Post Opening Road Safety Audit Report

Collins Street, Hobart TAS – Bicycle Lane Trial

Final2 Report 21/08/2026

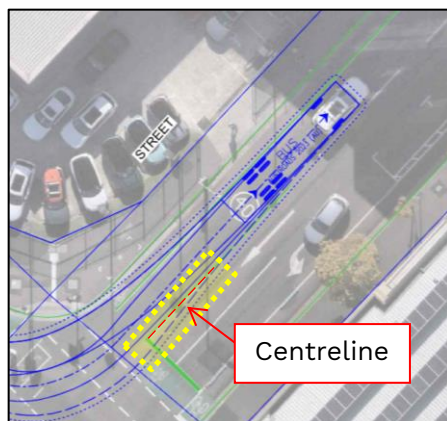
1.4.	Buses turn left from Barrack Street into Collins Street from the central lane and overhang the centreline on Collins Street when turning. Review of pre-installation of the bicycle lane aerial photos indicate that to accommodate the separate left turn lane, the centreline of Collins Street was relocated and reduced the width of the departure lane by approx. 1.0 m. Swept path analysis (refer to Appendix 3 – Swept path assessment) indicates that prior to the works, buses were still required to turn from the central lane. However, buses can no longer complete the turn without crossing the centreline. There is a risk that turning buses will: — strike a vehicle propped at the hold line on Collins Street — mount the kerb to avoid a car propped at the hold line and strike a pedestrian waiting at the crossing.	Widen the departure lane on Collins Street to ensure buses can turn left from Barrack Street into Collins Street without crossing the centreline or mounting the kerb (P) Consider rerouting the bus (P)	Likelihood: Unlikely Severity: Fatal Risk rating: EXTREME Safe system energy: Above tolerance

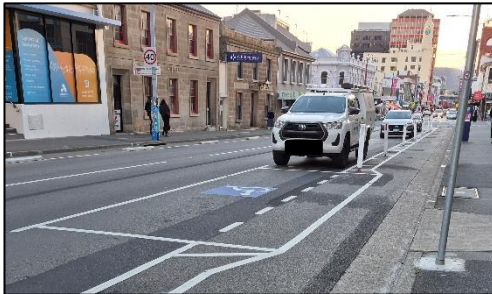
- 1.12. DDA car parking is line marked into the bicycle lane to achieve the space width required under AS2890.2.

The line marking provides the 3.2 m width of the car parking space but provides a dashed line to indicate where drivers should park to maintain the width of the bicycle lane.

Cars were observed parking over the indicative line, reducing the effective width of the bicycle lane and increasing the likelihood of a dooring collision with the lack of a buffer zone.

The width of DDA spaces is required to provide loading/unloading area for wheelchairs on both sides of the vehicle. Therefore, some vehicles may be required to park within the buffer zone to provide space for passengers to exit the vehicle on the roadside.

There is insufficient road width to provide a compliant DDA space and adequate bicycle lane width.

Consideration should be given to installing green pavement treatment within the bicycle lane adjacent to the DDA space to increase awareness of the cyclists at the conflict point (S)

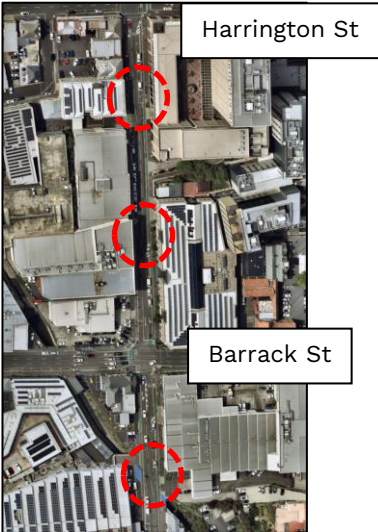
No	Audit findings	Audit recommendations (P) = Primary (S) = Supporting (O) = Other	Risk rating / safe system energy	Client response	
				Accept: Yes/No	Reasons/Comments
1.15.	There is insufficient storage for vehicles between Victoria Street and the zebra crossing. If a vehicle turning right out of Victoria Street turns while a pedestrian is on the crossing, they will prop partially blocking north-eastbound traffic and are at risk of being struck by a through vehicle.	Consider relocating the zebra crossing to the southwest to provide storage for one vehicle between the zebra crossing and Victoria Street (S)	Likelihood: Possible Severity: Insignificant Risk rating: LOW Safe system energy: Below tolerance

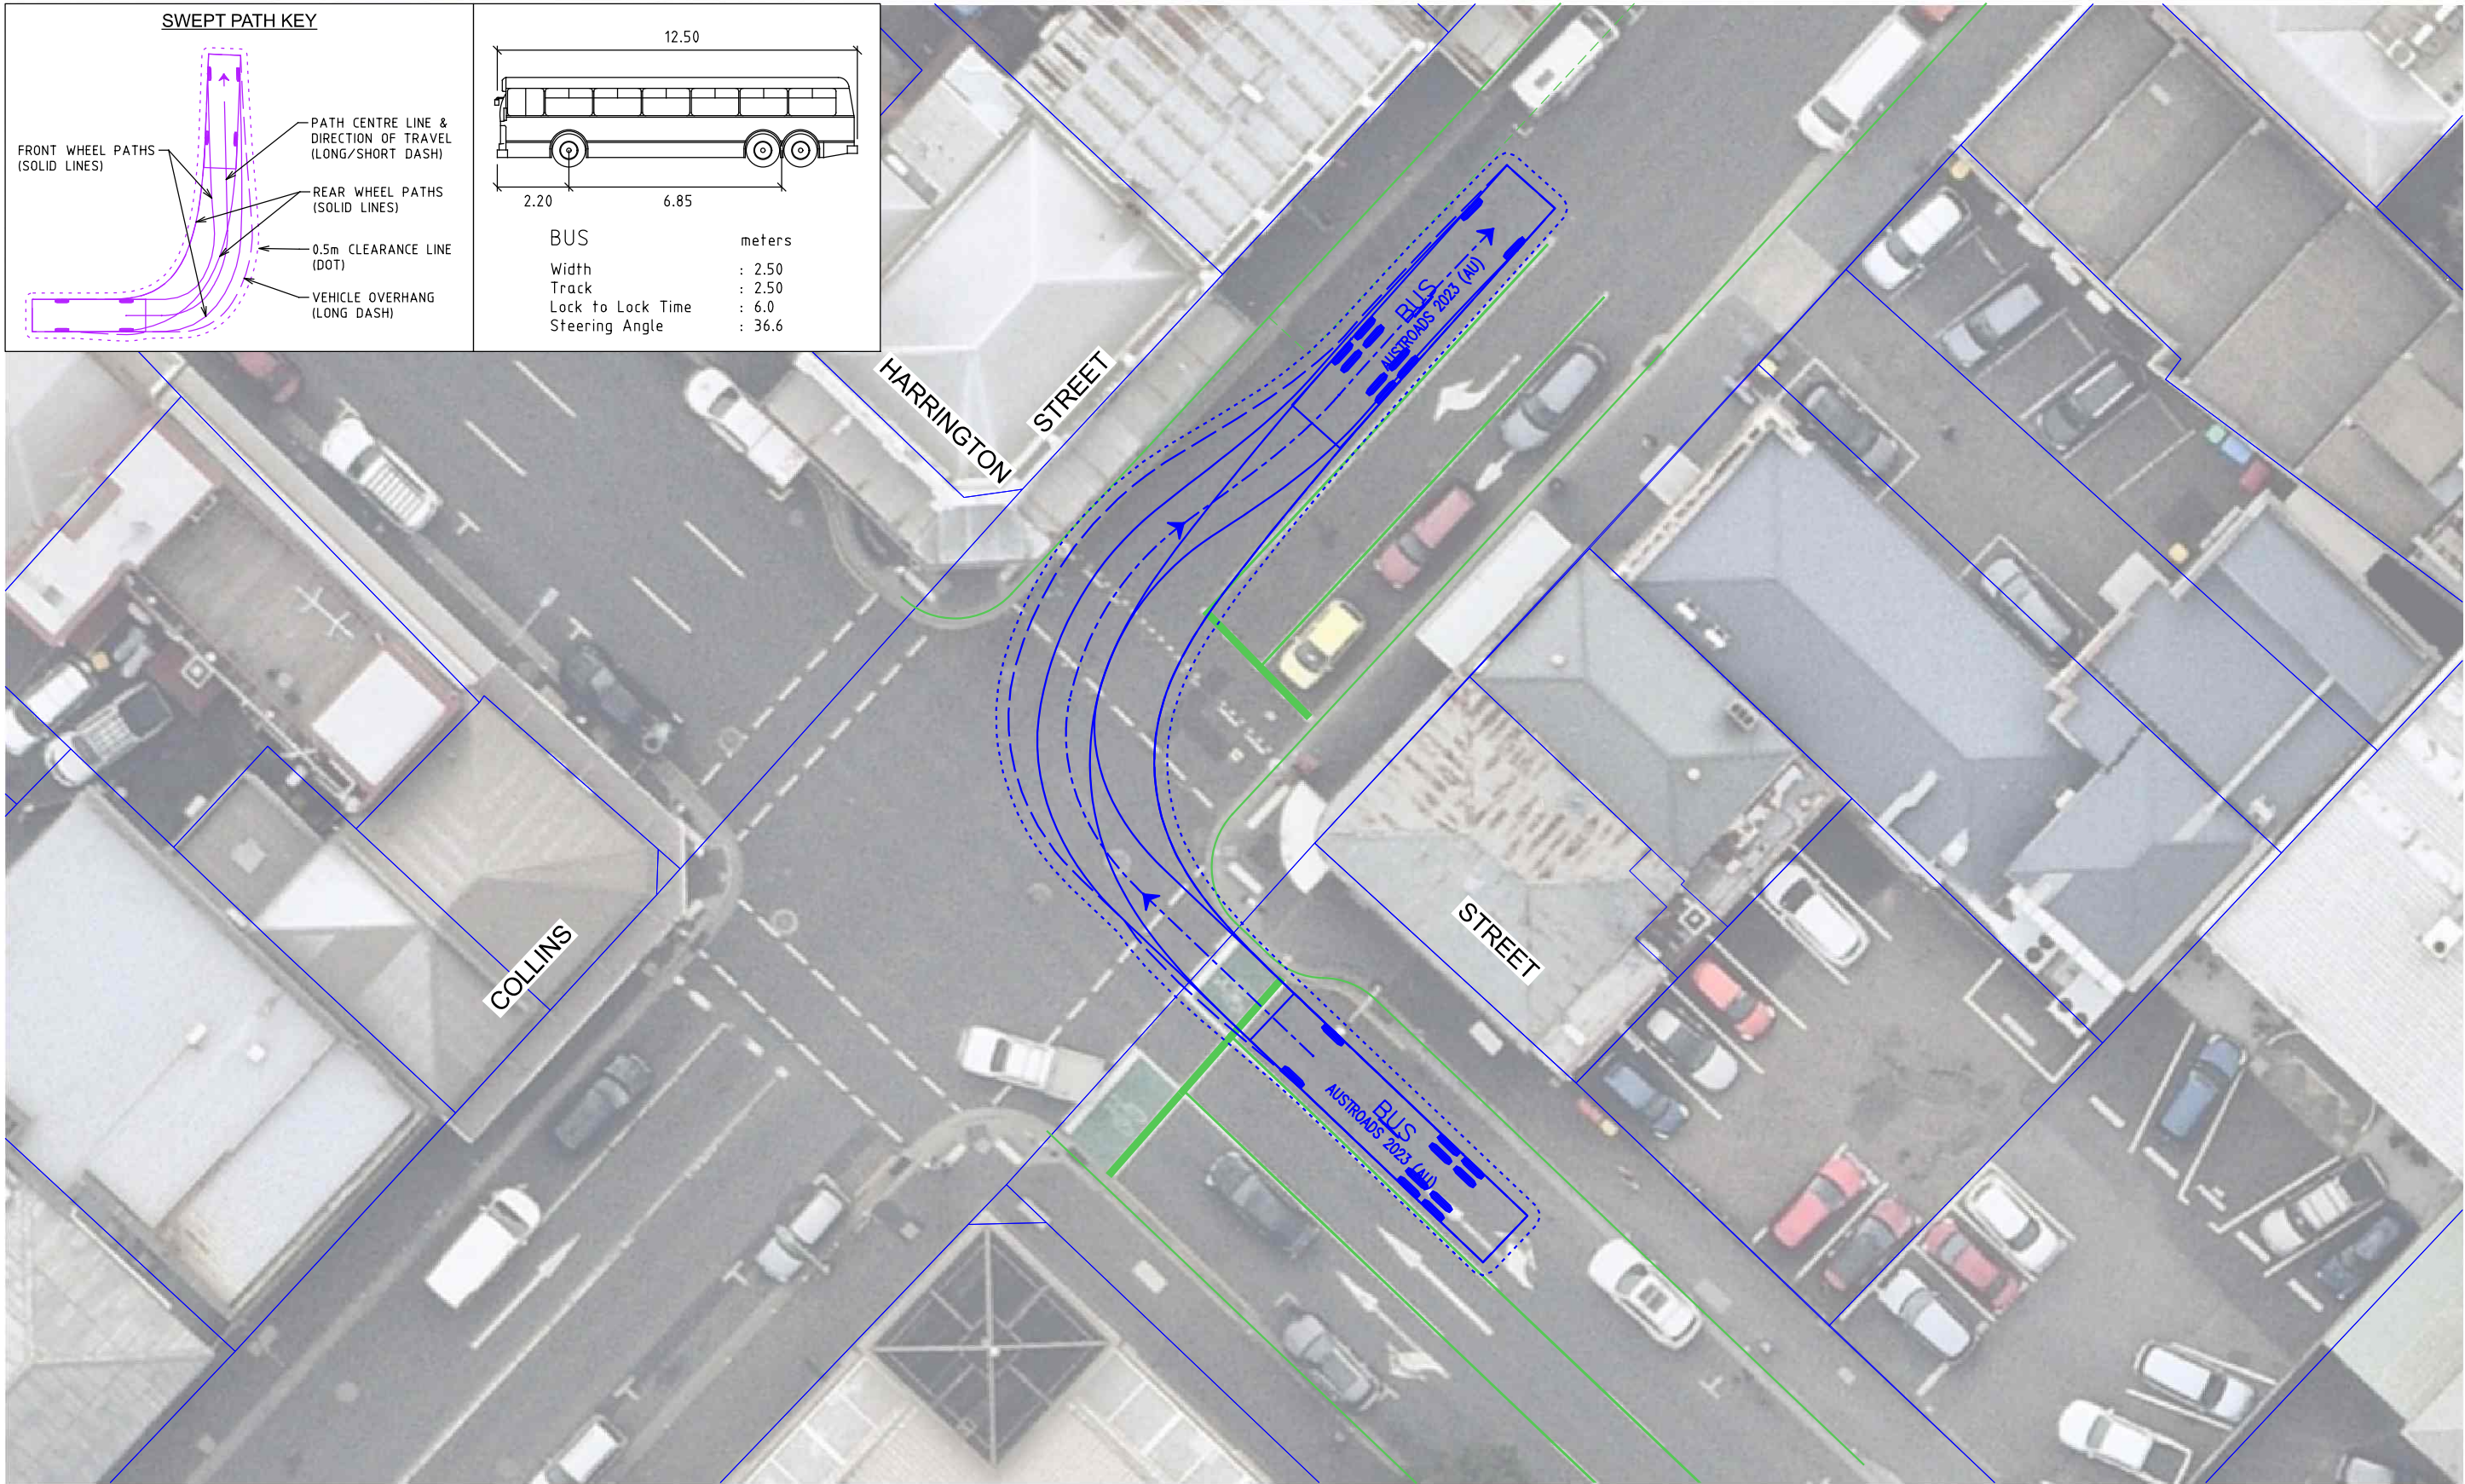
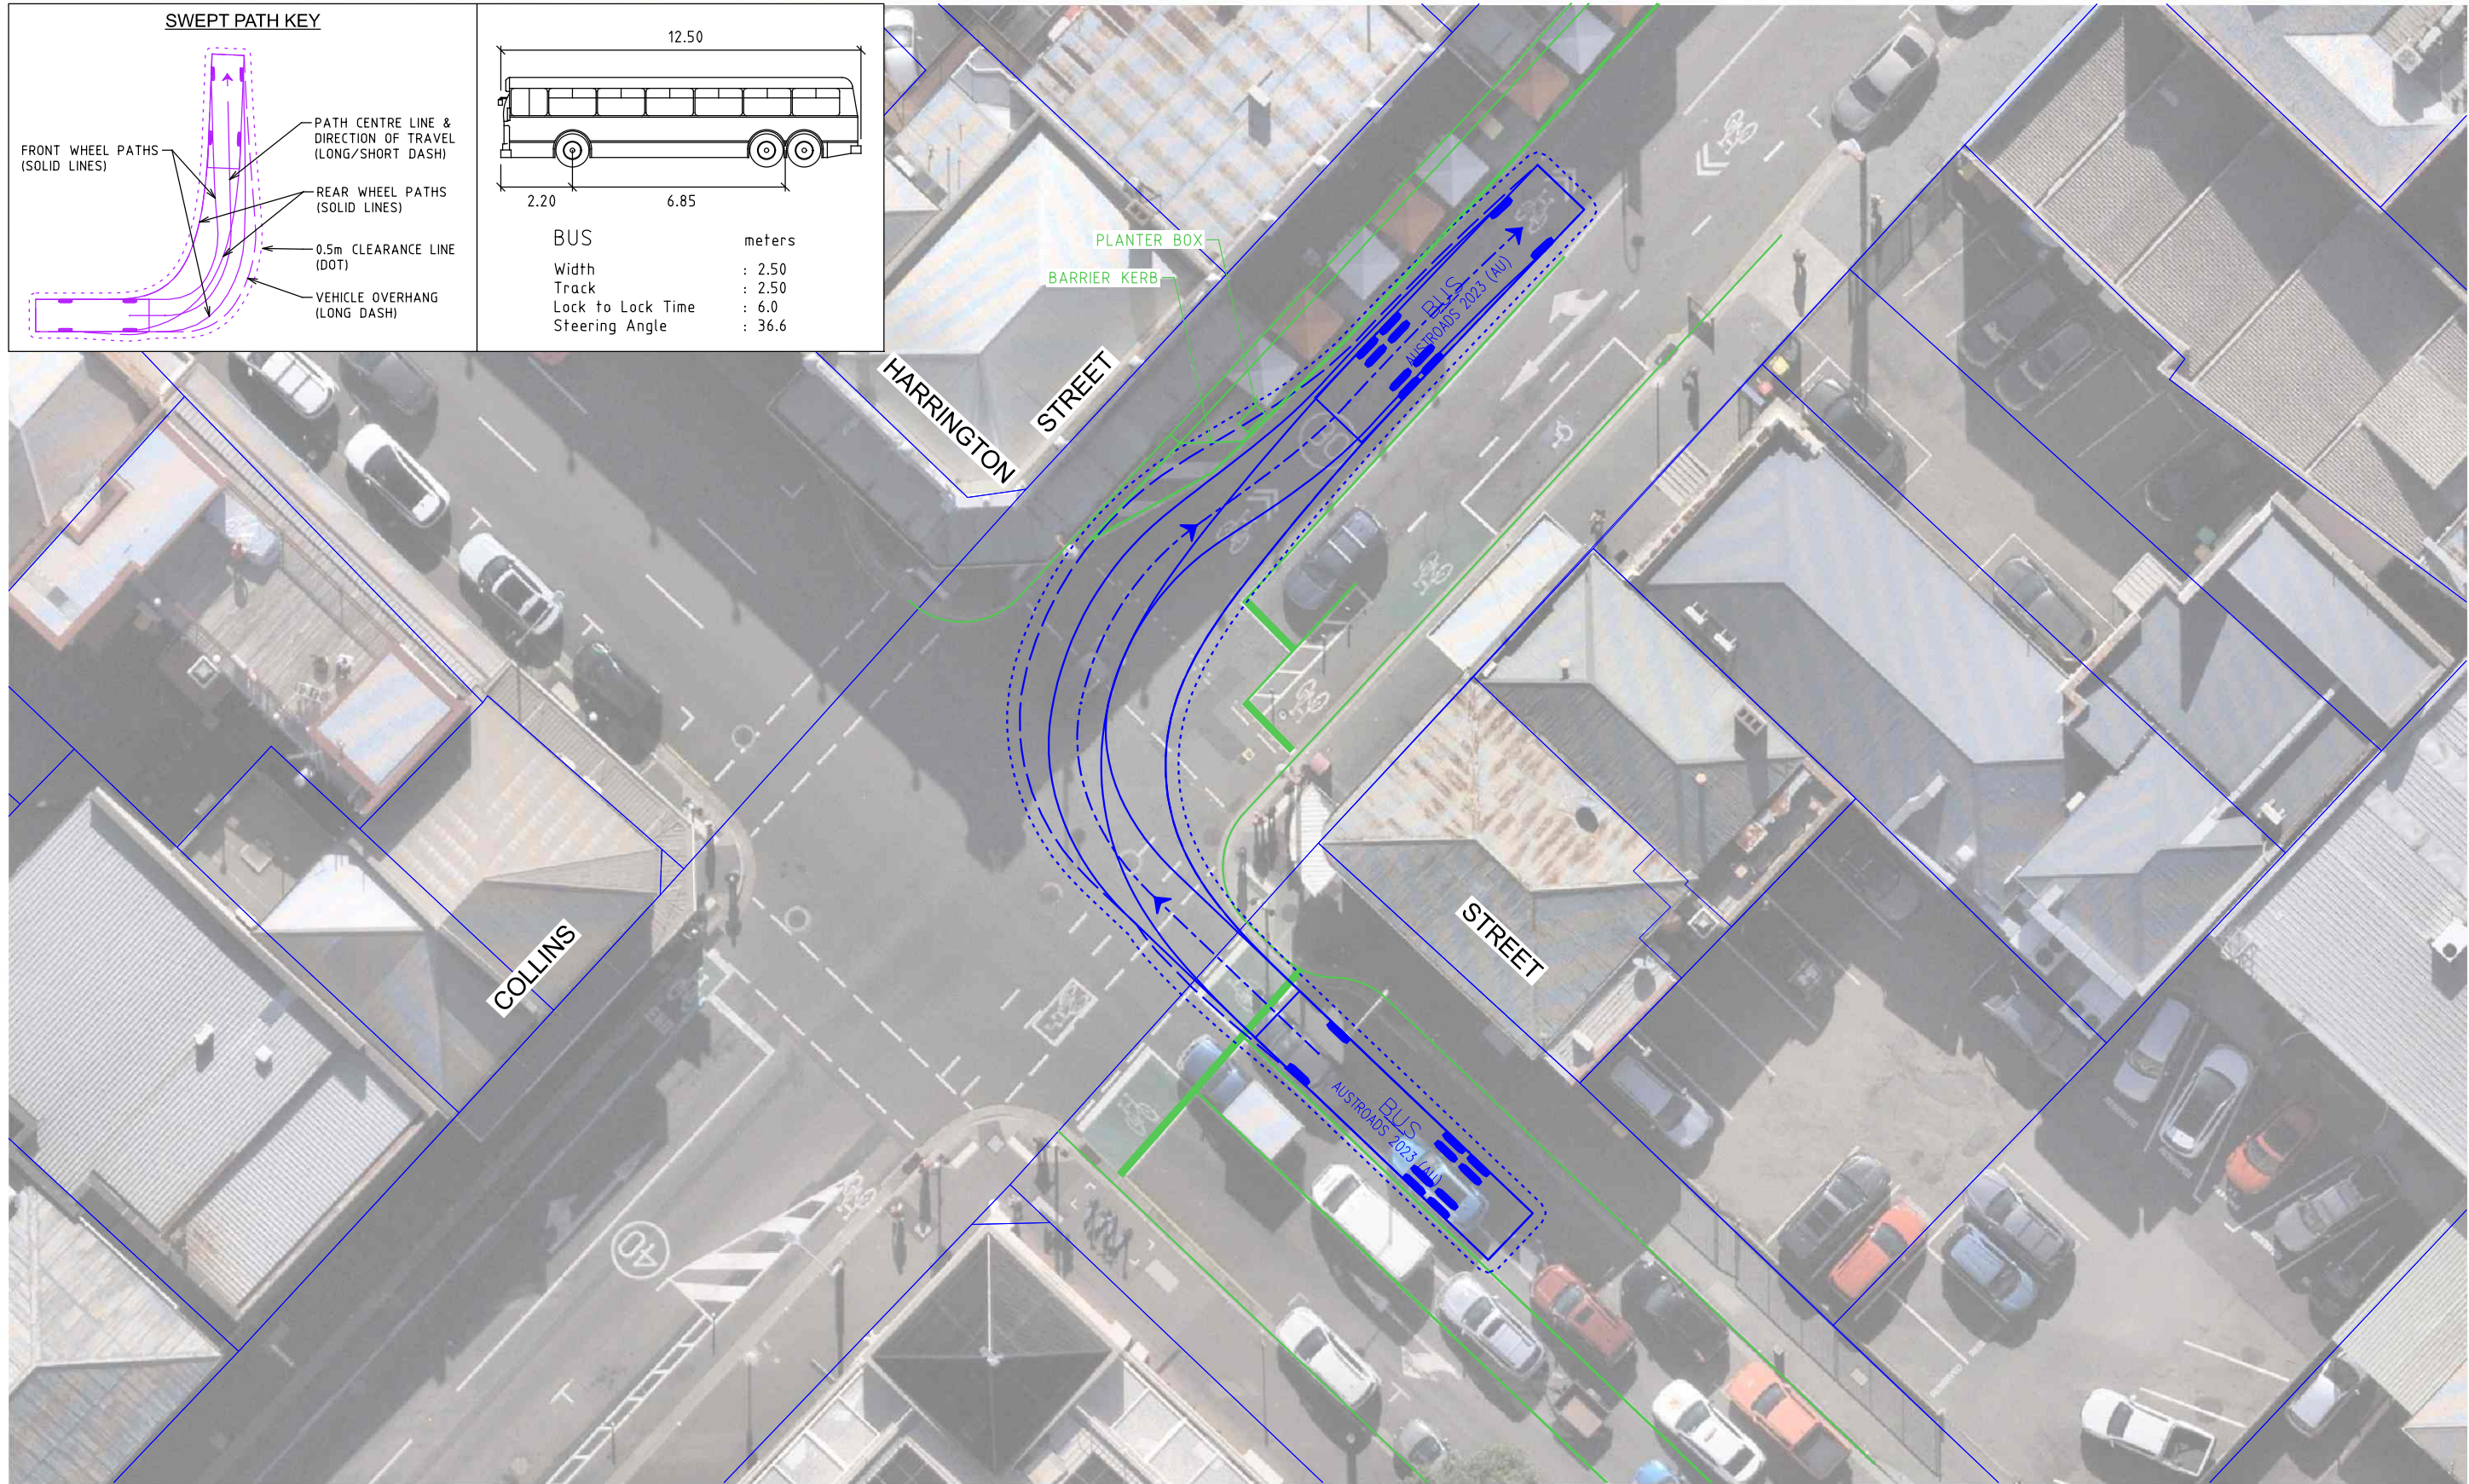
1.3.	Buses turn right from Harrington Street into Collins Street. Buses were observed turning from the central lane and requiring to significantly slow down to complete the turn. Swept path assessment (refer to Appendix 3 – Swept path assessment) indicates that prior to the installation of the outdoor dining area, buses could turn into Collins Street from the kerbside traffic lane. The impact to the bus turning swept path increases the risk of: — buses side swiping roadside furniture or southbound vehicles at the hold line on Collins Street — rear end collisions for trailing vehicles on Harrington Street who are not expecting buses to significantly slow down during their turn.	Remove part of the outdoor dining kerb outstand to ensure buses can turn right from Harrington Street into Collins Street from the kerbside lane (P)	Likelihood: Likely Severity: Insignificant Risk rating: MEDIUM Safe system energy: Below tolerance
